SERVICE BULLETIN

TR-7800

841

SUBJECT: TR-7800 Clock and Display Failure

▼ CONTROL UNIT (X53-1180-XX) XX: 10(K), 61(W)(T)

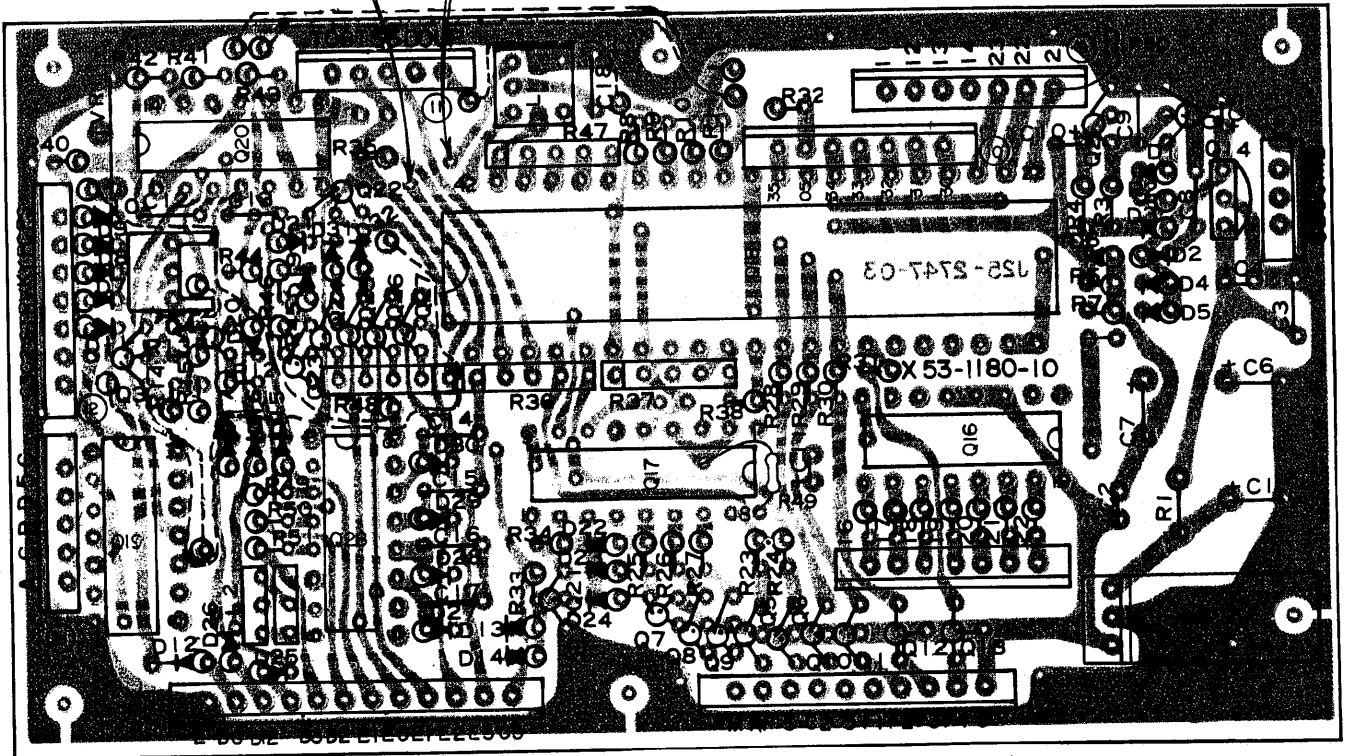
Failure of the display may be caused by an intermittent via-hole (through-hole without a lead) in the microprocessor clock circuit. Hard-wiring the holes will cure this problem.

On the Control unit X53-1180-xx, hard-wire the two via-holes as shown.
